NAGRA VI SERVICE BULLETIN

To use an external keyboard or other equipment on the host USB, 3 pull up resistors need to be added on the digital unit PCB. 9132 220 000.

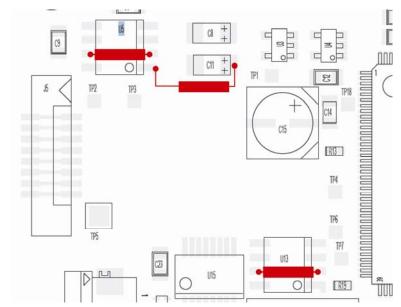
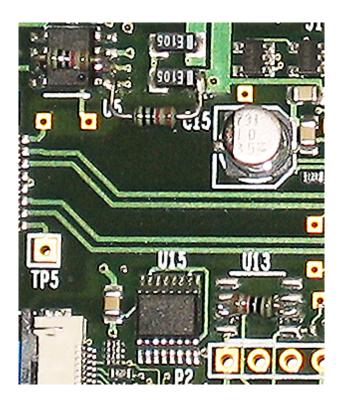
See the pictures concerning the position of the 3 resistors.

Add a resistor of 10 k Ω :

Between pin 2 & 7 of U5 Between pin 2 & 7 of U13 Between U5 pin 1 and C11 pin +.
